PUBLIC INTEREST TECHNICAL REVIEW FOR GROUNDWATER APPLICATIONS

TO: Water Rights Section Date: 8/17/2026
FROM: Groundwater Section Byron Ebner / Travis Brown
Reviewer's Name
SUBJECT: Application G - 19499 Supersedes review of _____

Applicant's Name: Brad Hazenberg County: Marion
Applicant(s) seek(s) 1.003 cfs from 1 well(s) in the Willamette Basin,
Mainstem Willamette subbasin
Proposed use Primary Agricultural Uses/Livestock Seasonality: 11/1 – 2/28

Water-Level Measurements in Nearby Wells

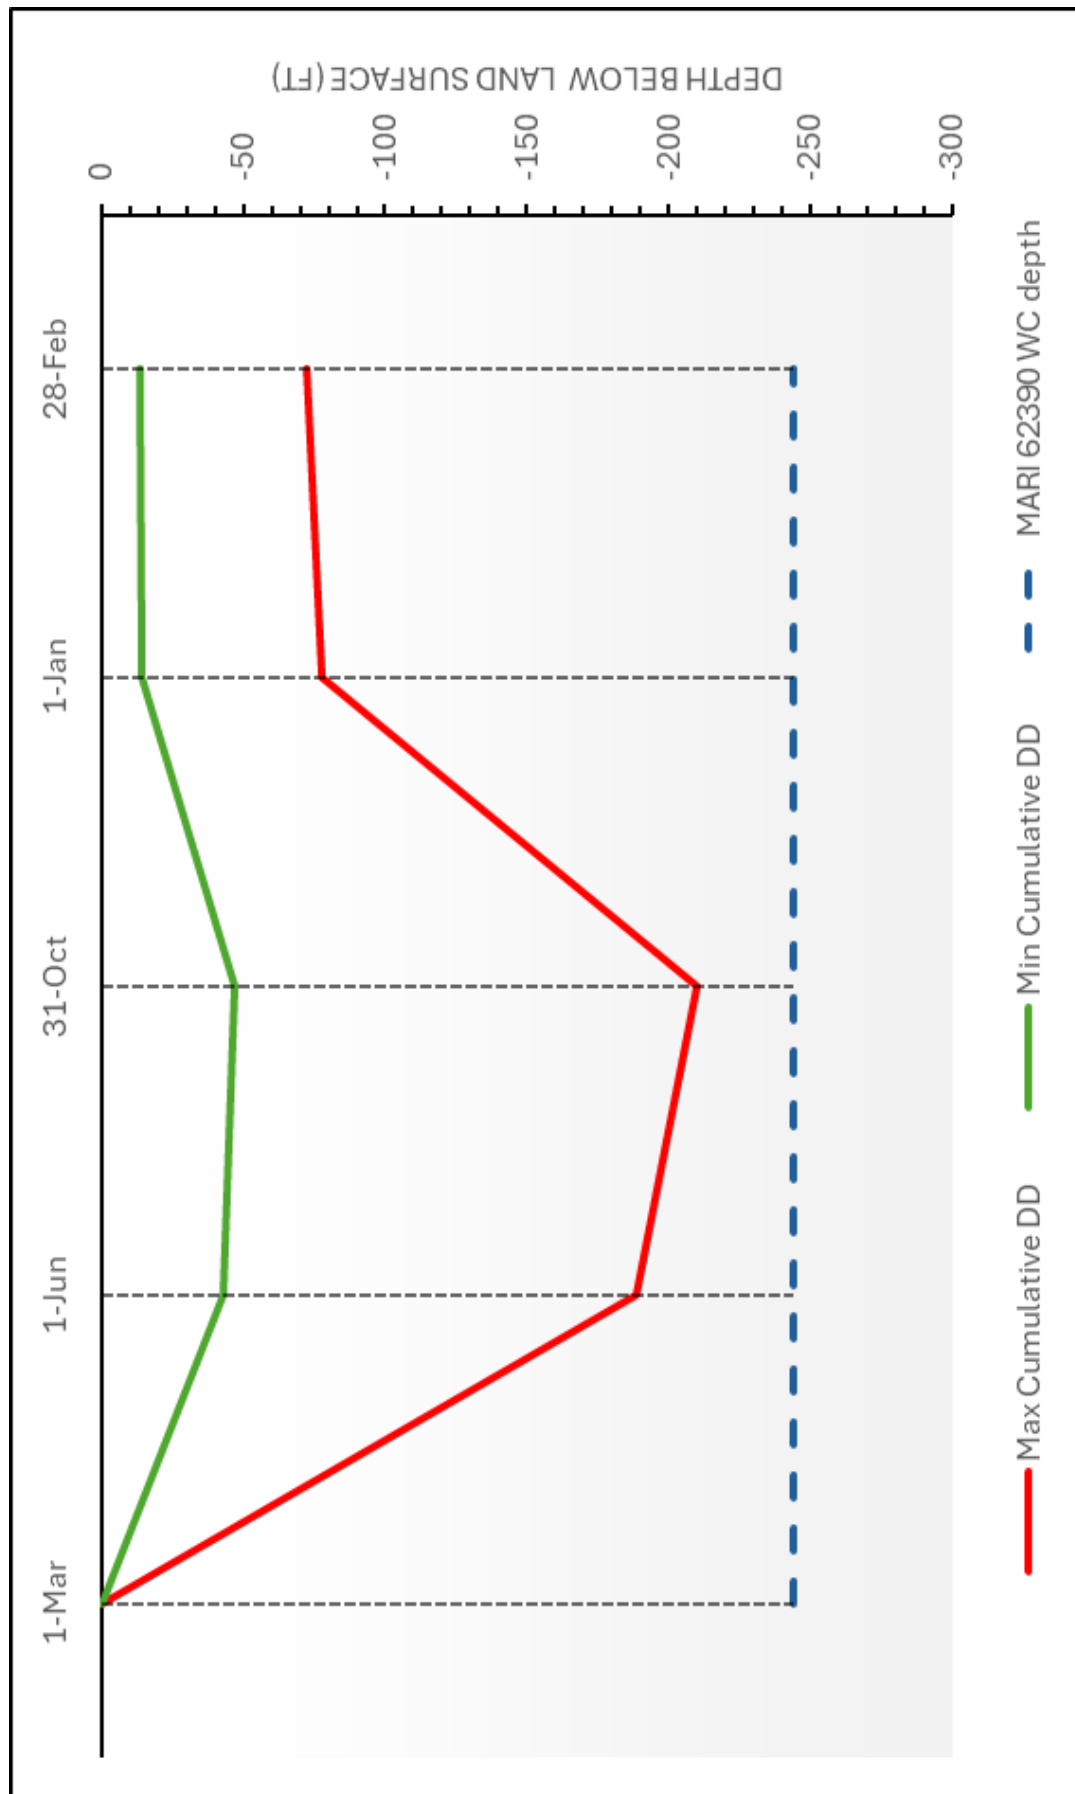
Comments: *Proposed POA has 3 reported measurements: one post construction measurement in August 2019, one non-static March 2025 measurement noted as "Rising" and measured 15 minutes after pumping, and one static March 2026 measurement. The highest known measurement would be the March 2025 (100.50 ft bls) measurement despite it not being static. MARI 50581, the nearest well with data to the POA, has questionable water level data due to the impact of near-continuous pumping for the dairy and apparently insufficient recovery time before collecting permit-required water level measurements. The most recent seemingly-reliable measurement from MARI 50581 (which was reportedly idled for 24 hours

before the measurement) was collected on March 18, 2025 and indicates a water level of 60.67 ft bls, which is 8.67 ft below the highest known water level for the well (52 ft bls on May 15, 1995; reported on the well log) and sufficient to pass the "Magnitude Test" (OAR 690-008-0001(9)(a)(B)); however, there are insufficient reliable measurements to evaluate the "Rate Test" (OAR 690-008-0001(9)(a)(A)). MARI 1072 likewise had insufficient reliable data to evaluate the "Rate Test" and the most recent seemingly reliable measurement was in 2005 – too old to evaluate the "Magnitude Test." The nearest representative well with sufficient data to evaluate both the "Rate" and "Magnitude" tests is MARI 1054, ~3,520 ft north of POA MARI 69050; MARI 1054 passes the "Rate Test" with water levels increasing over the past 11 years at a (Theil-Sen) rate of 0.67 ft/yr, but it fails the "Magnitude Test" with 35.4 ft of total decline between 2026 (35.4 ft bls) and its reference level in 1988 (42 ft from its well log). However, water level measurements in MARI 1057, ~2,370 ft northwest of MARI 1054 and ~4,650 ft north of POA MARI 69050, pass both the "Rate" and "Magnitude" tests, despite substantial and seemingly near-continuous use for dairy operations under Certificate 98500. Similarly, MARI 1050, ~6,820 ft northeast of POA MARI 69050, passes both the "Rate" and "Magnitude" tests.

Comments: **Since all evaluated wells near the proposed POA MARI 69050 with sufficient data pass the "Rate Test" and the majority of evaluated wells pass the "Magnitude Test" – notably including MARI 50581 immediately adjacent to POA MARI 69050 – the preponderance of the evidence indicates that water level in the subject part of the groundwater reservoir are "Reasonably Stable".**

Theis Cumulative Drawdown Analysis for Certificate 88839 (MARI 62390)

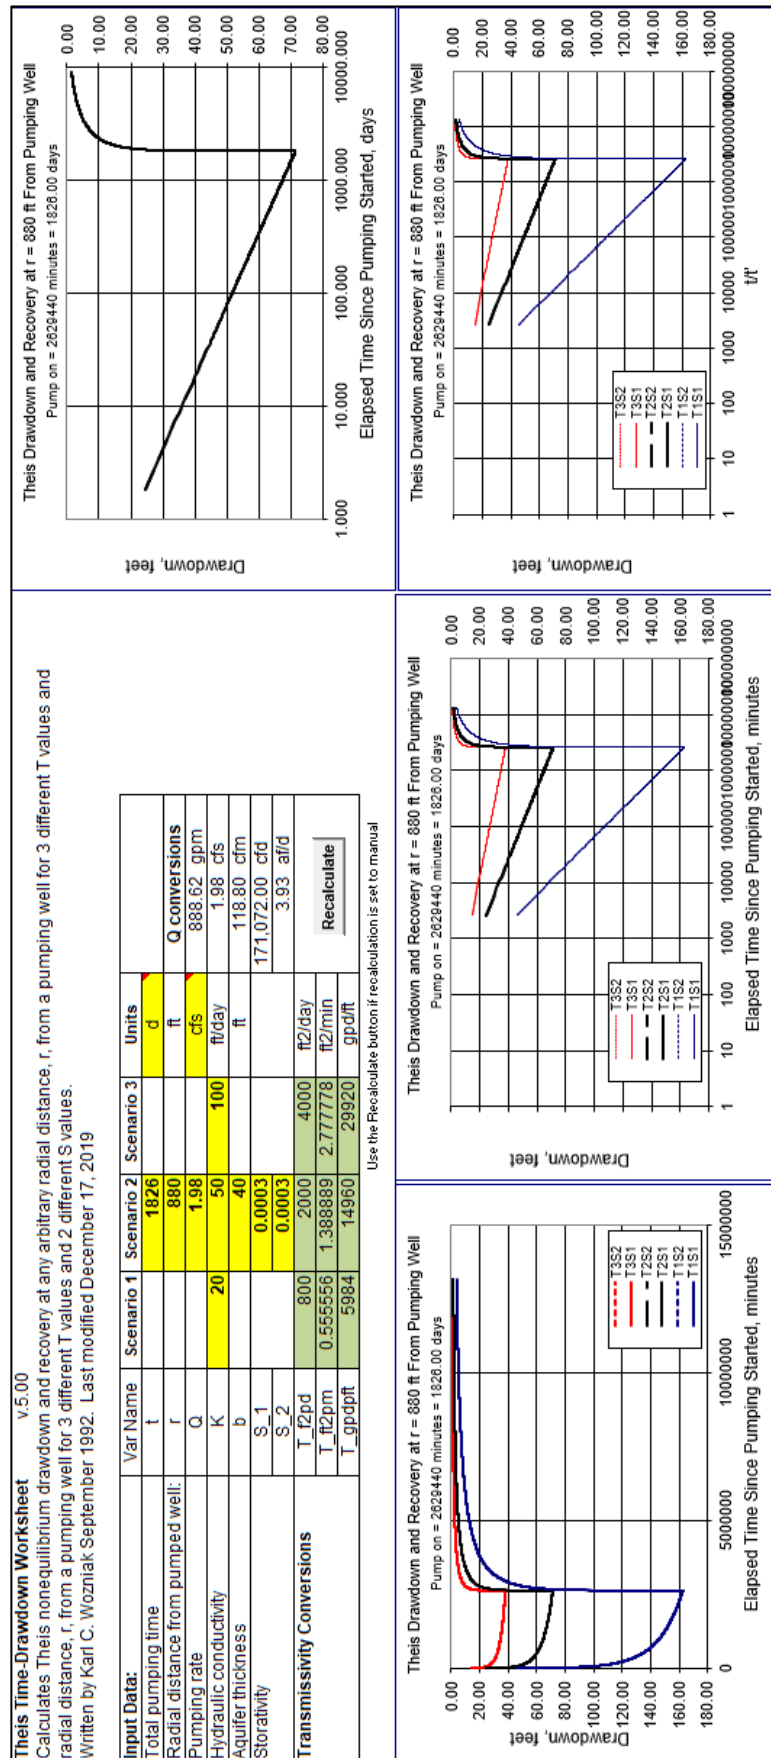
The POA for Certificate 88839 (MARI 62390) is 1660 ft from the proposed POA. Assuming constant use at max rate, the requested water use would likely not injure Cert 88839. However, in addition to the requested period of use associated with this permit (11/1 – 2/28), the proposed POA is an authorized POA for Certificate 98500, which has primary and supplemental irrigation rights that equal a combined max rate of 1.98 CFS. The estimated combined and supplemental rate noted on OWRD’s Water Rights Information Query for Certificate 98500 is 0.3636 CFS with the period of use being 3/1 – 10/31.

A Theis (1941) drawdown analysis was conducted to assess potential well-to-well interference on MARI 62390 that may occur due to pumping from the proposed POA from the existing water right Certificate 98500 as well as the requested rate from this application. Hydraulic parameters used for the analyses were pulled from nearby pump test reports, well reports and Conlon et al. (2005). Estimated drawdown on MARI 62390 from pumping the proposed POA, assuming the water table is fully recovered from the previous season and constant use at max rate is 46.8 – 210.2 ft. According to the well report for MARI 62390, the depth of the water column is 244 ft from a SWL measurement taken in 2009. Considering that groundwater levels in this area are reasonably stable and constant use at max rate is unlikely to occur for agricultural and livestock use, injury isn’t likely to occur.

An additional drawdown analysis using the same parameters was performed on MARI 1128, which is roughly 880 ft from the proposed POA. Drawdown from pumping the proposed POA 1.98 CFS year-round for 5 years results in an estimated drawdown of 38 – 162.6 ft. The maximum rate associated with exempt use wells is approximately 10.41 gpm, which is miniscule compared to the rates associated with the proposed POA. A conservative estimate of drawdown on MARI 1128 was gained by using a 1.98 CFS rate at constant use for 5 years combined with constant use at the max rate of 10.41 gpm (0.0232 CFS). The total estimated drawdown from pumping these two wells is 167.2 ft. According to the well report for MARI 1128, the water column is over 220 ft deep. Based on the above information, injury isn’t likely to occur.
